CONDITIONS OF APPROVAL:

[Shadow Green Section One Final Plat_2018.12.10.pdf](#)

2nd Submittal_Shadow Green Section One Final Plat_2019.01.03.pdf

34. Total number of lots

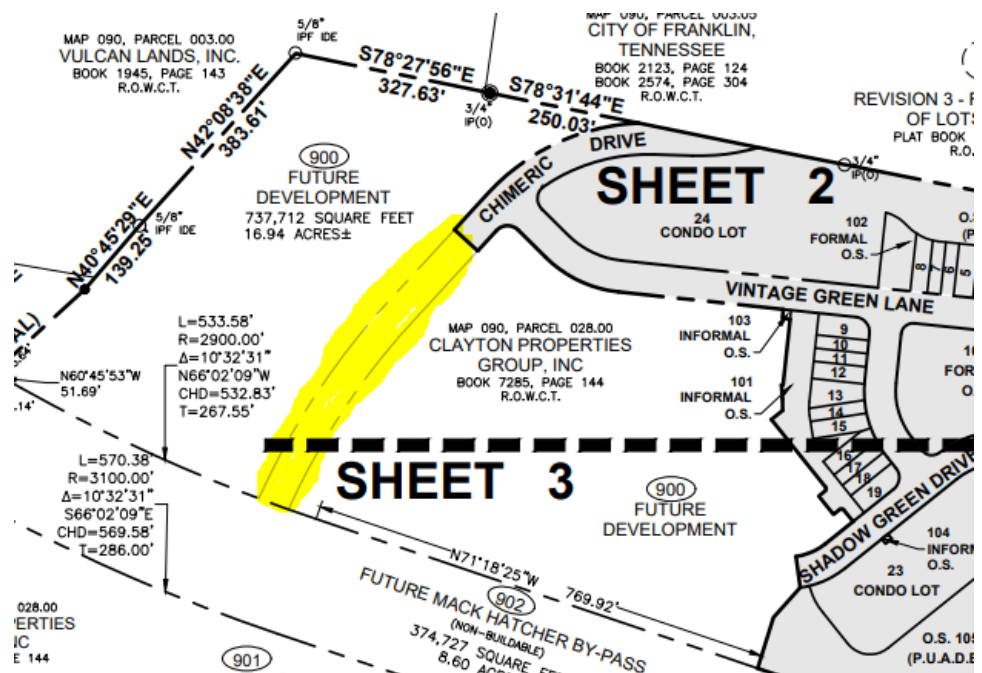
christopher.andrews@franklinton.gov The total number of lots should be reflective of all platted lots, not only those with residences.

Please include all residential, open space, and large lots (the lots labelled as those within the 900 series) in the total.

18. Platting of Future Development

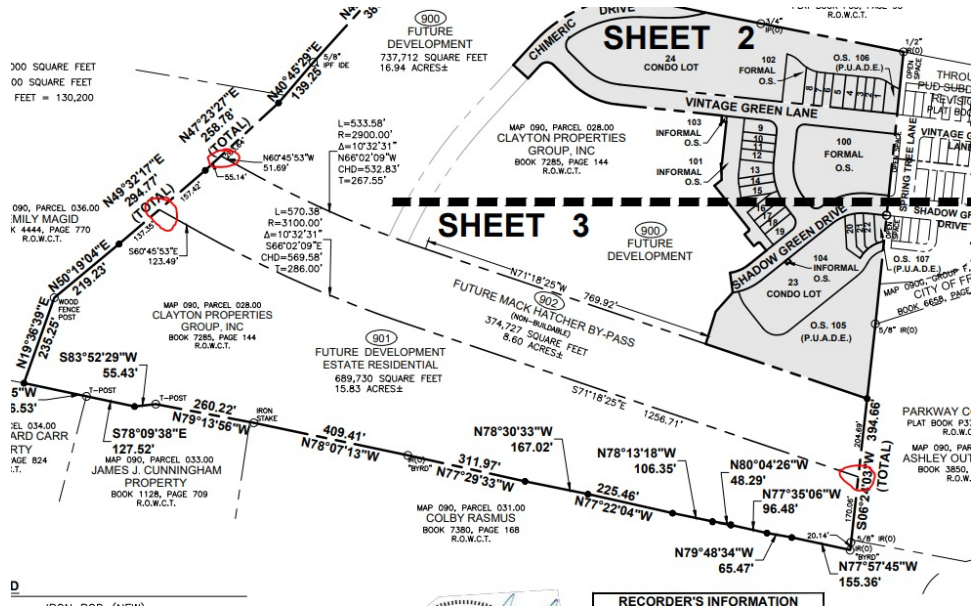
christopher.andrews@franklintn.gov Currently, the plat submitted is noted as creating future development lots. Those lots are not labelled on the plat.

(Currently, Tract 1 and Tract 2 are not listed as lots. Nor is the Mack Hatcher ROW.)

Please revise the plat to include those lots, and assign lot numbers. (You may choose to use a "#00-series" system, example: Lot 900=Tract 1, Lot 901=Tract 2, Lot 902=Mack Hatcher ROW).

The placement of iron pins would need to be shown on plat, along with each call.

For future sections, final plats would void and vacate any lots created through the Shadow Green Section 1 Final Plat.

Please include necessary pins or iron rods for all lots to be created, specifically for the lot representing the future Mack Hatcher ROW.

tdarnall@ragansmith.com Future Development lots have been numbered on the plat.
